# knitter-switch

## Product-Change Notification

Products affected: DBS 2002, DBS 2003, DBS 2004, DBS 2005, DBS 2006, DBS 2007, DBS 2008, DBS 2009, DBS 2010, DBS 2012, DBS 2102, DBS 2103, DBS 2104, DBS 2105, DBS 2106, DBS 2107, DBS 2108, DBS 2108 F, DBS 2108 SW, DBS 2109, DBS 2110, DBS 2112

### Revision of contact parts and case

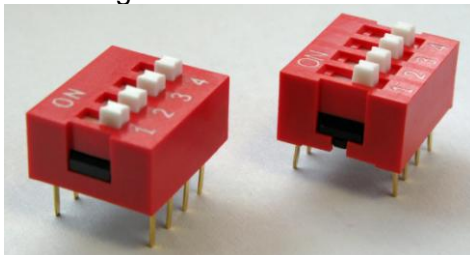
Soldering with slider in „ON“ position may deform the movable contact and possibly cause reliability problems. Therefore the contact structure was revised:

Up to now

From now on
